SUBJECT: Forwards draft responses to Reactor Sys Branch questions which will be discussed during 800821 meeting. Responses to Questions 211.201, 211.266, 211.267, 211.268 & 211.269 will be provided on 800821. *See Report*

SUSQUEHANNA STEAM ELECTRIC STATION  
RESPONSES TO REACTOR SYSTEMS BRANCH QUESTIONS  
ER 100450 FILE 841-2  
PLA 518

Attached are PP&L's draft responses to the Reactor Systems Branch questions which will be discussed during the meeting on August 21, 1980.

FIGURE 5.1-3a

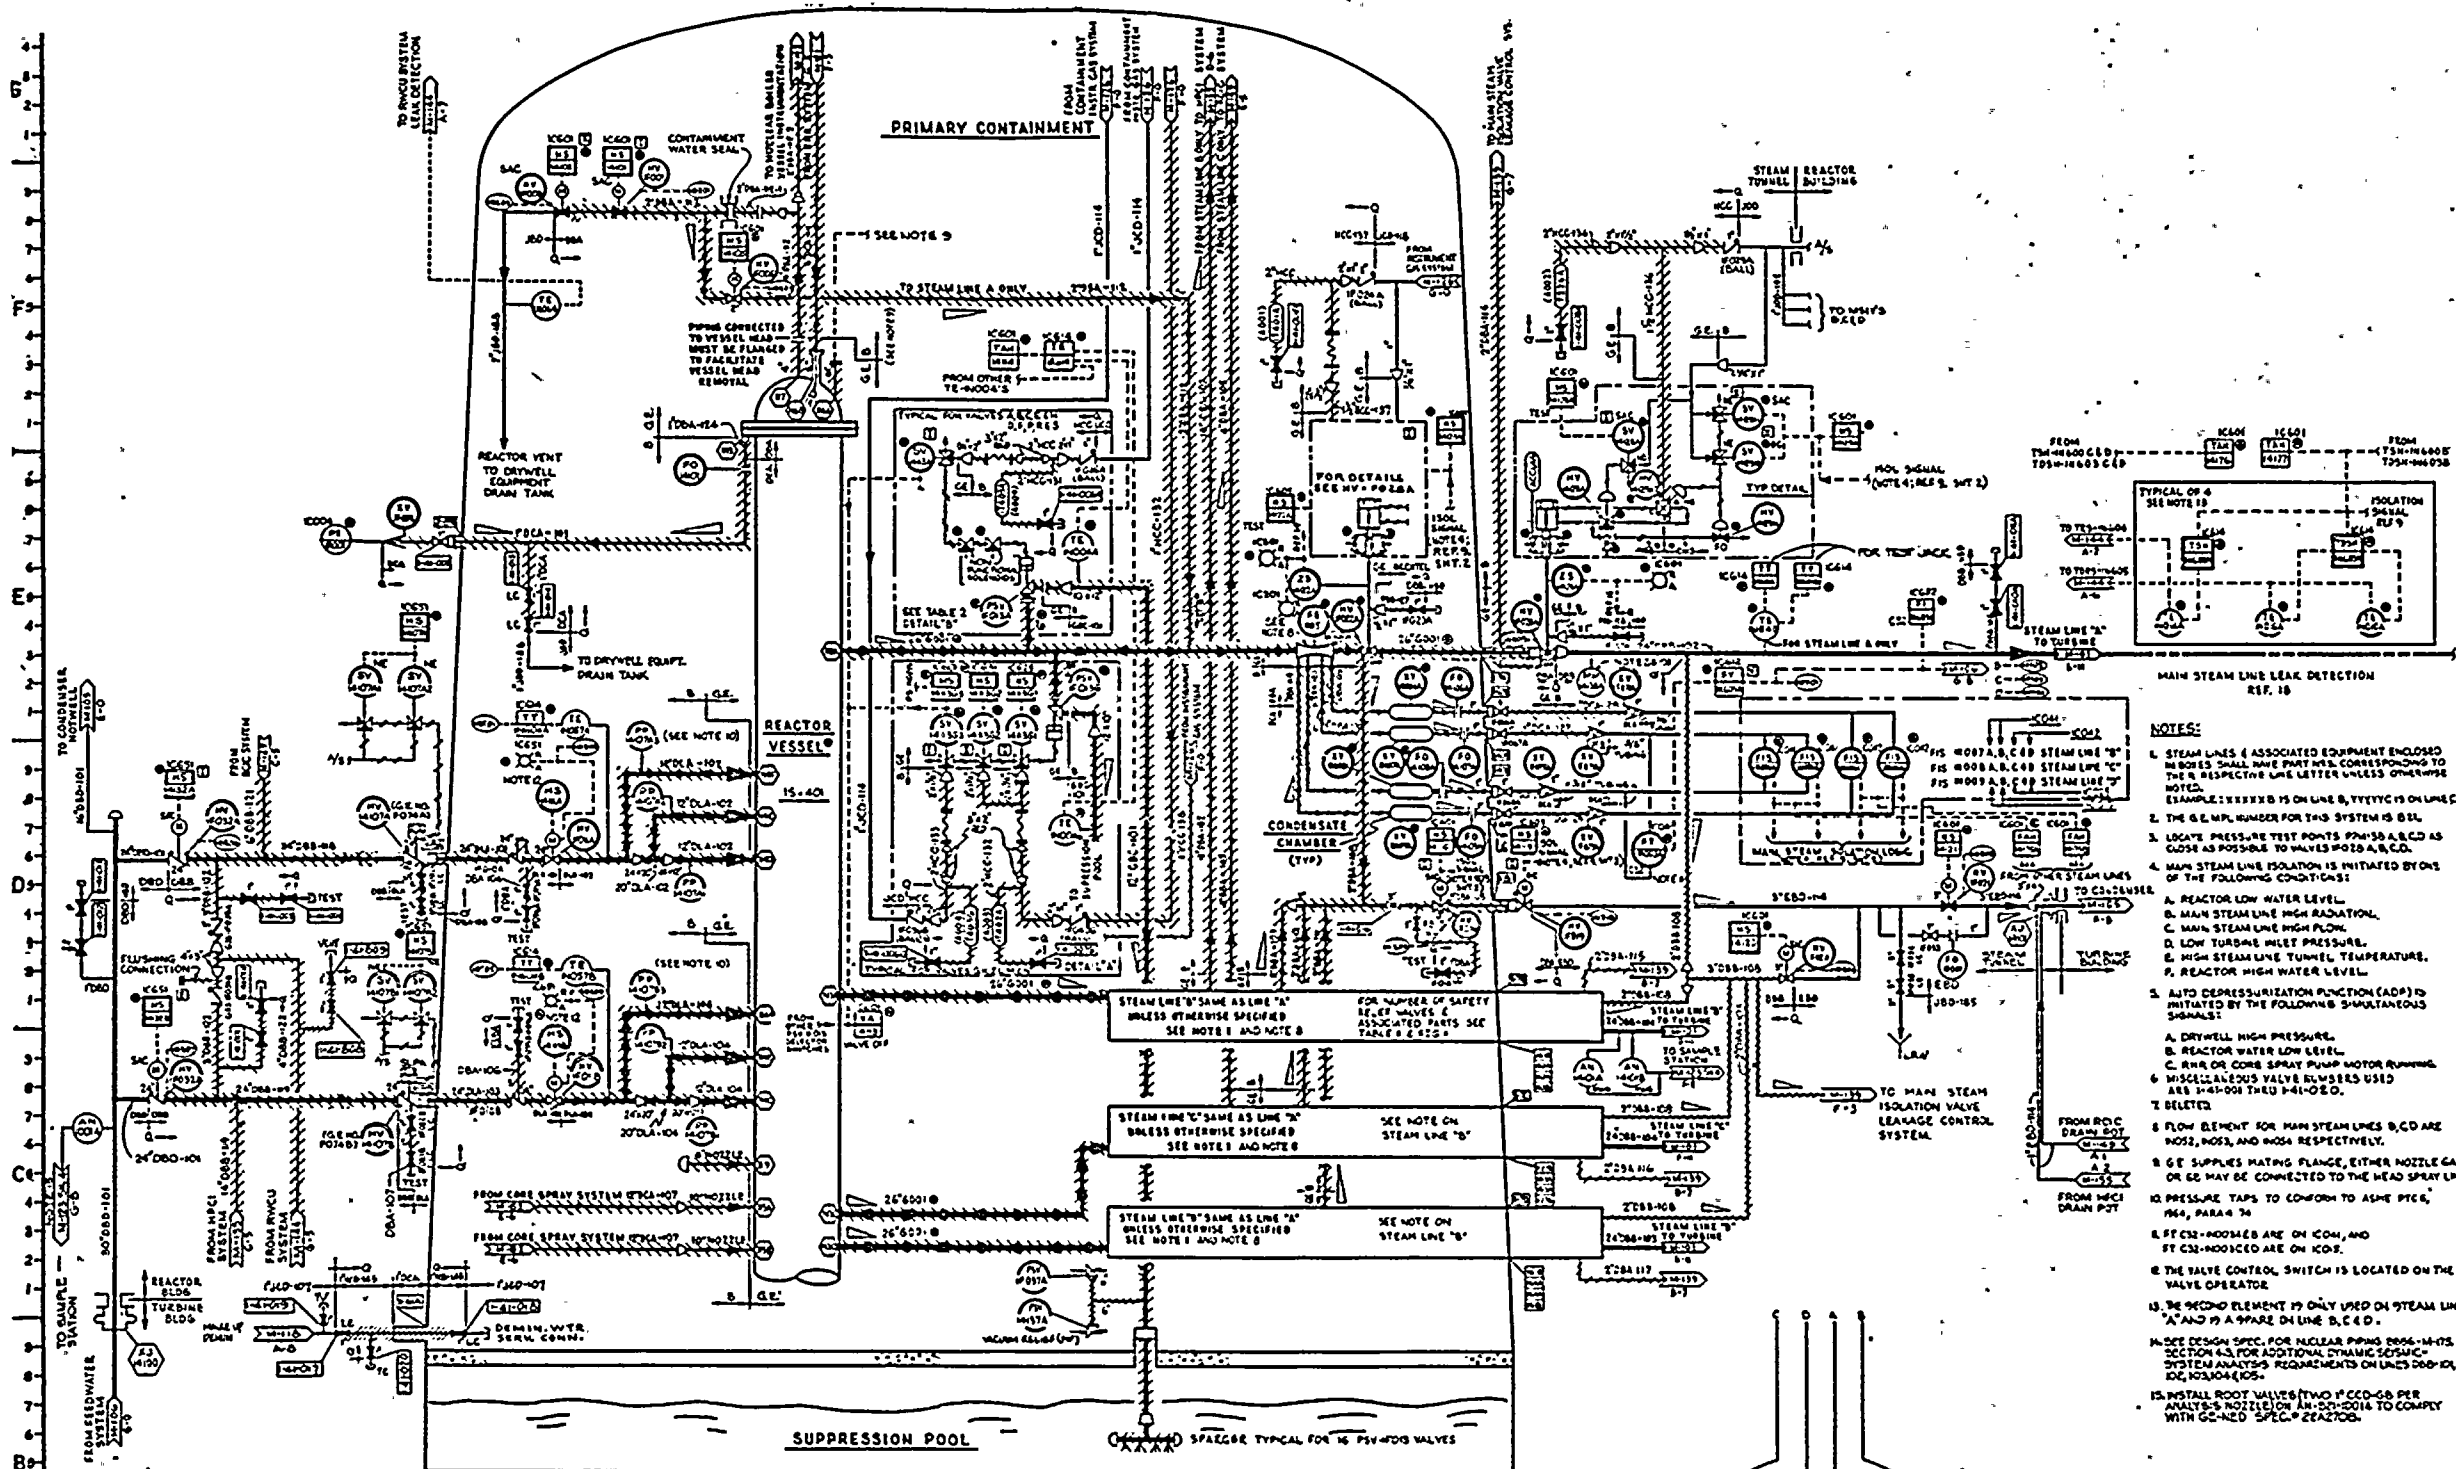
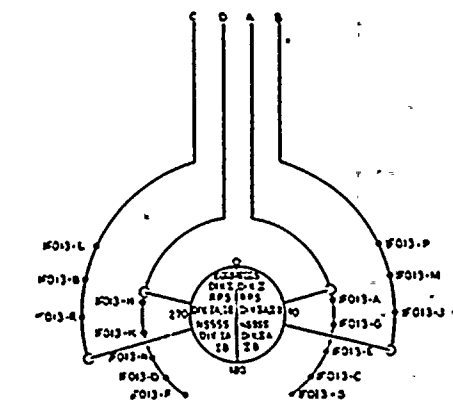
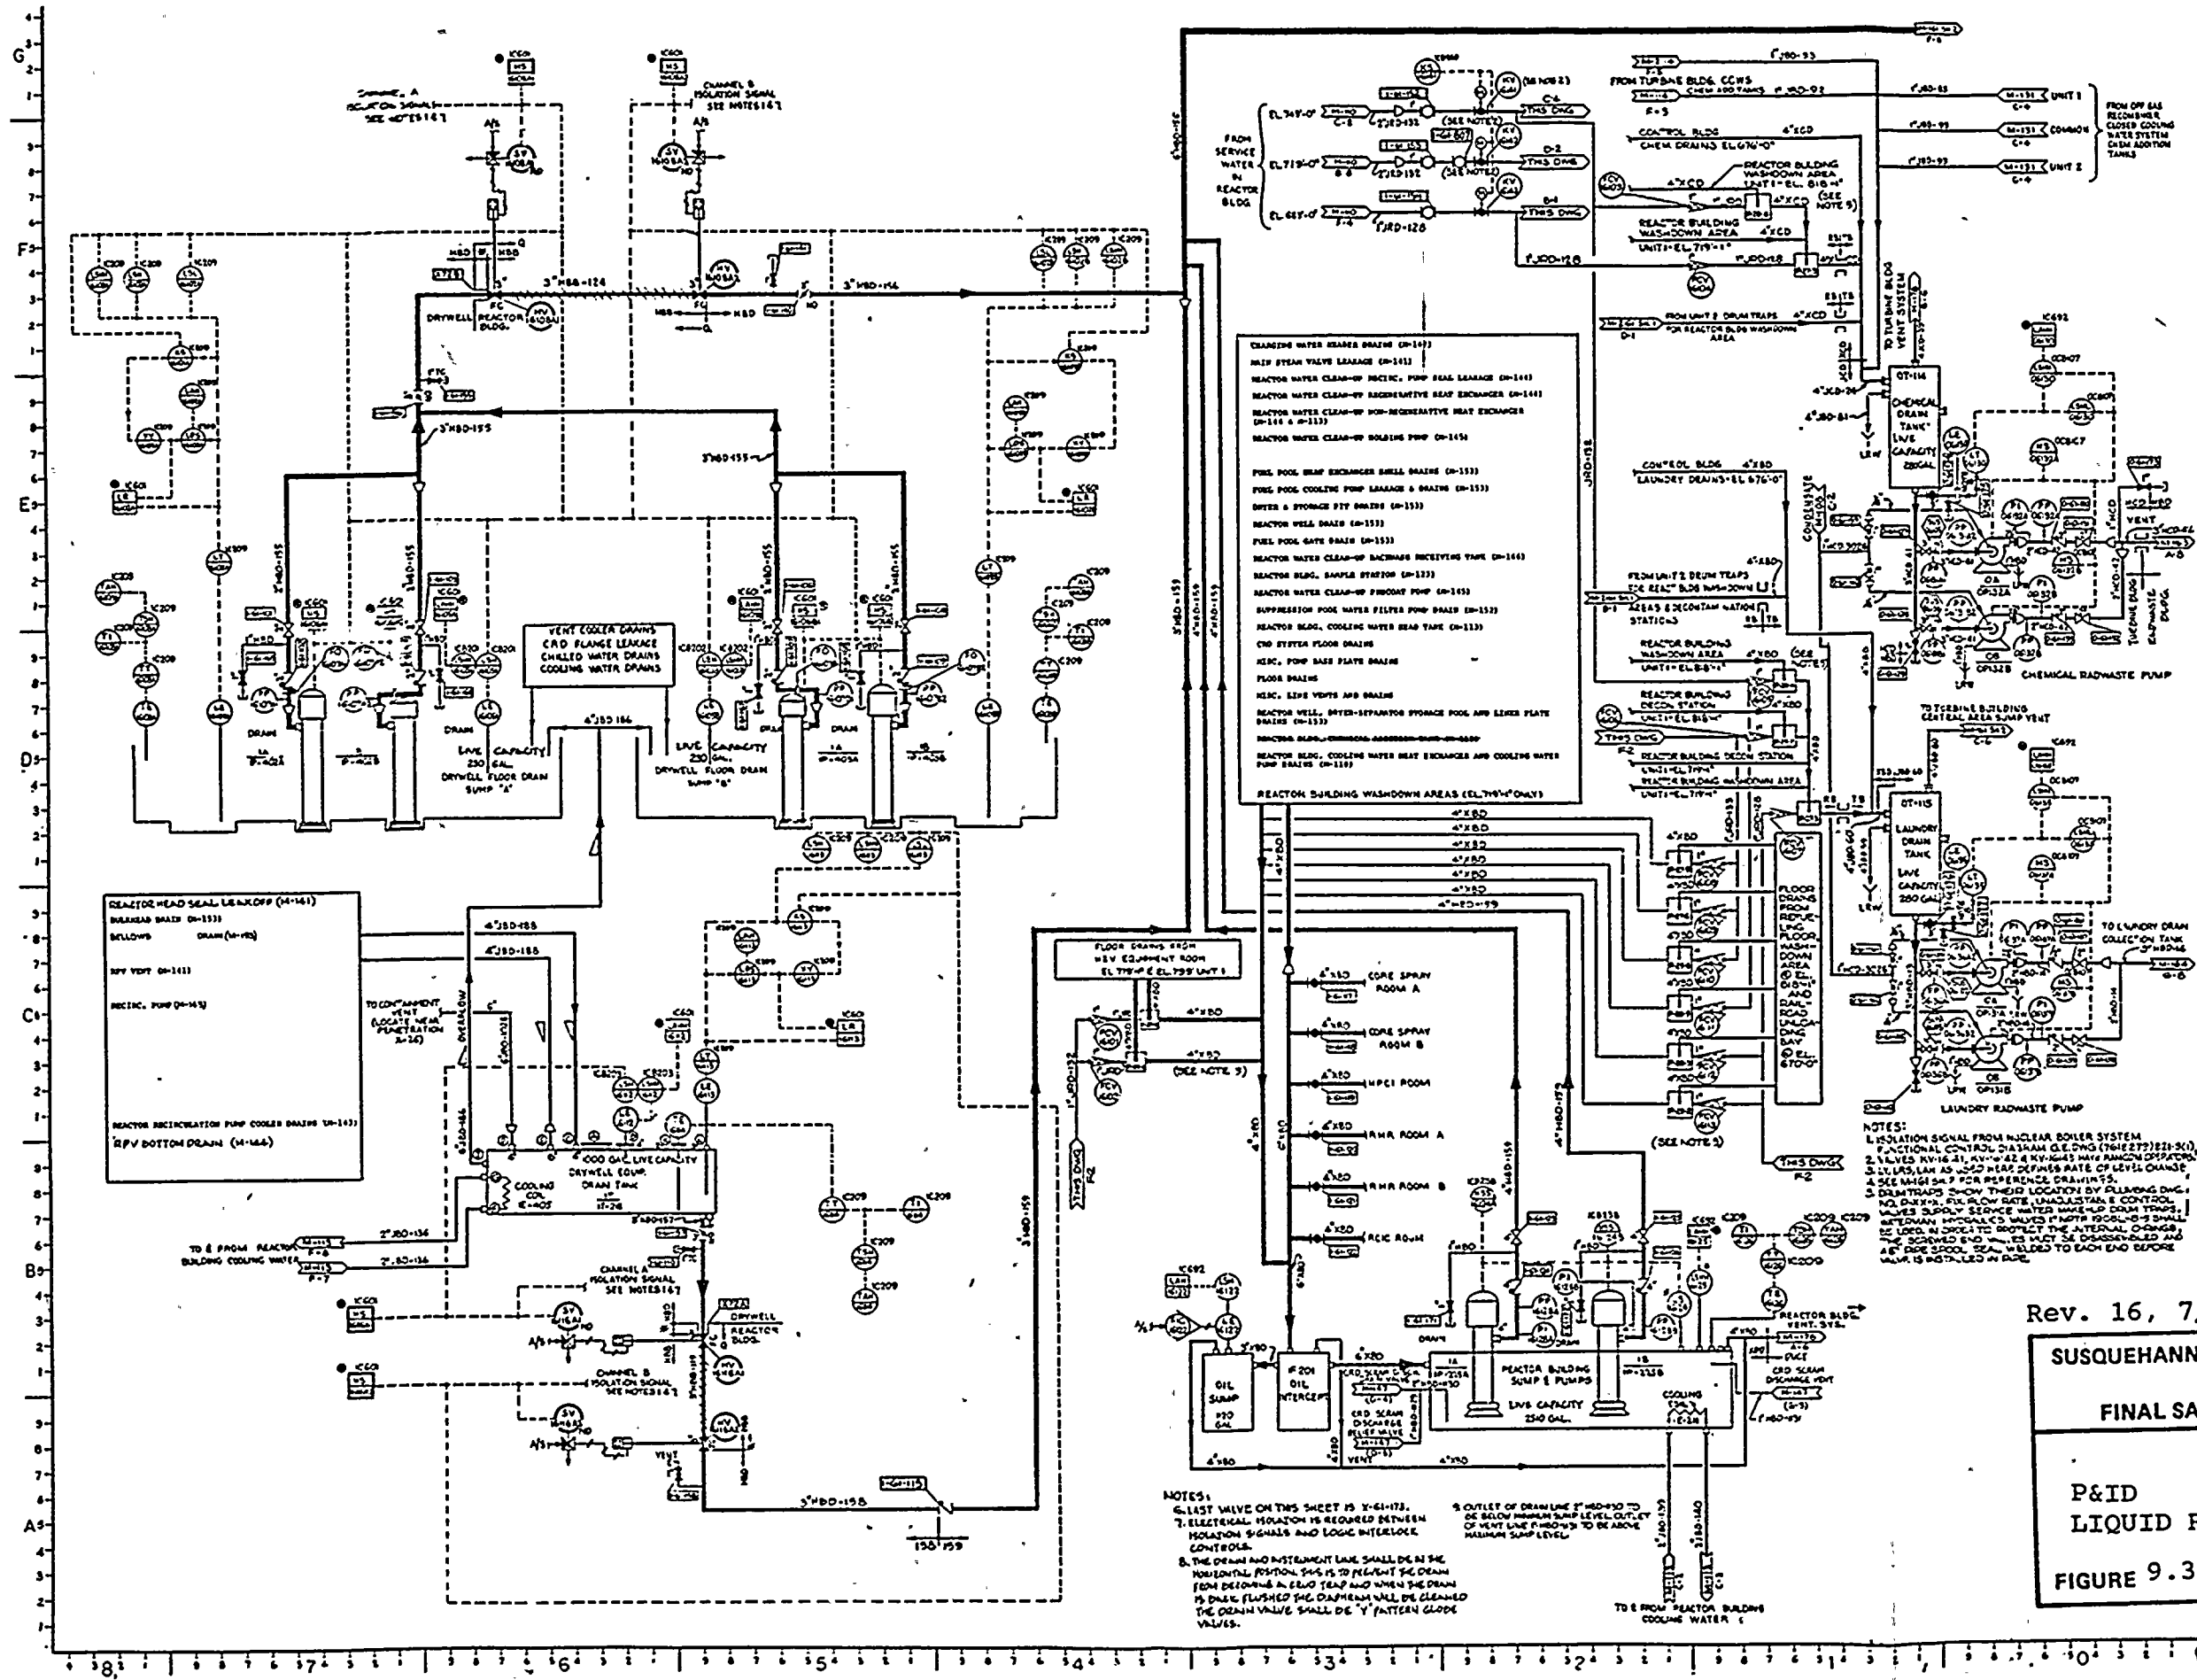
In Subsections 5.2.5.2, on page 5.2-54, you state:

- (a) "The recirculation valve packing leakoff connections are piped to the drywell equipment drain through normally closed isolation valves." Show this on P&I diagram M-143.
- (b) "The main steam isolation valve packing leakoff piping is provided with a normally closed isolation valve, and is capped." "Keeping these leakoff connections isolated provides two sets of packings for limiting steam leakage." Estimate the increase in unidentified leakage as a result of the above feature.

In Subsection 5.2.5.2 the sentence, "the recirculation valve packing leakoff connections are piped to the drywell equipment drain through normally closed isolation valves," has been deleted. As stated in FSAR Subsection 5.2.5.2, each recirculation valve packing leakoff connection is provided with a normally closed isolation valve, and is capped.
